June 12, 2014

Oregon State University  
Capital Projects Contract Administration  
Agricultural Systems Management Center

### ADDENDUM NO. 2

**E6.1R**  
SHEET OF

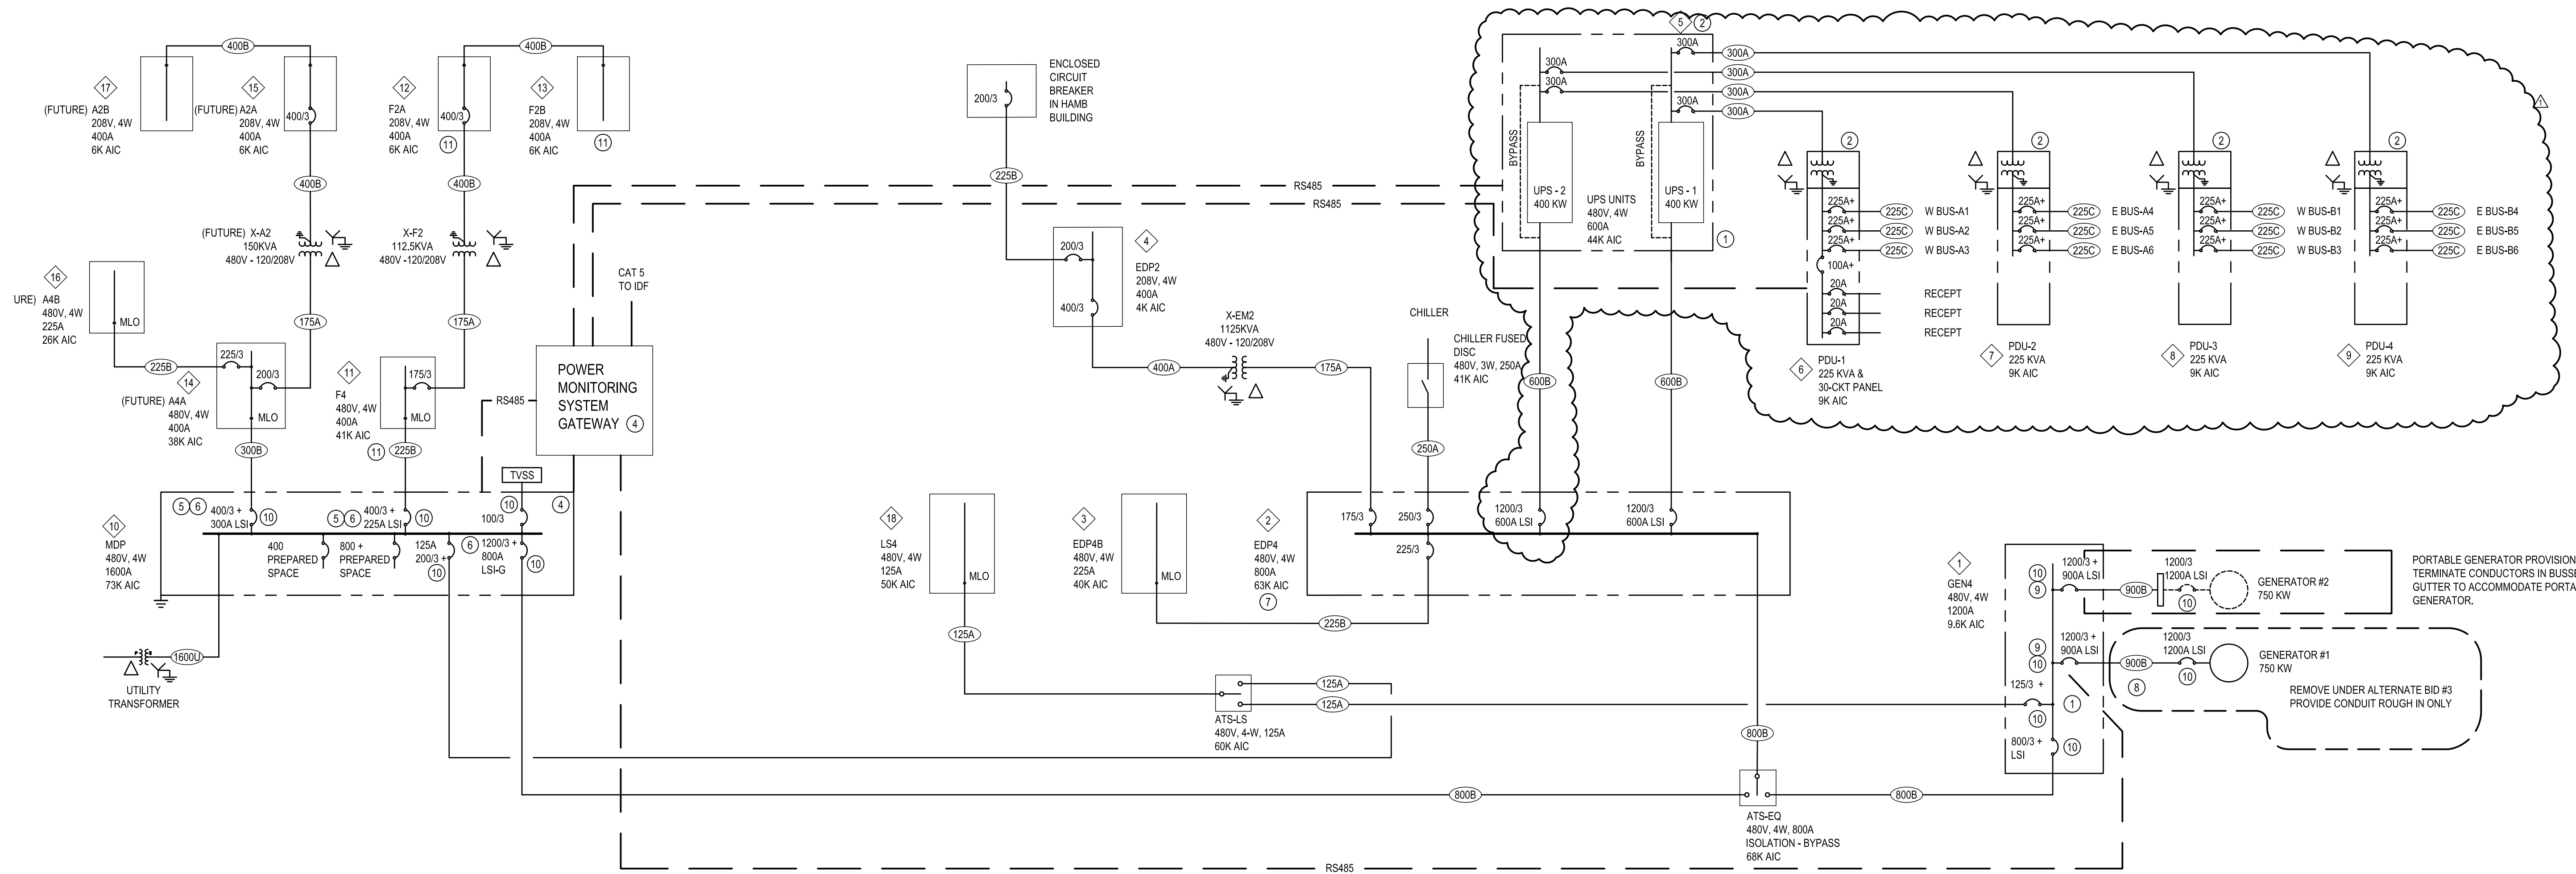
- A. Revise UPS and PDU quantity, configuration and rating per attached drawing E6.1R – Revise Bus duct home runs per attached drawing E6.1R, dated 06/12/14. Replace 1200/3 circuit breaker in Panel EDP4 with (2) 600/3 circuit breakers. Replace 600 amp feeder to UPS assembly with (2) 600 amp feeders.
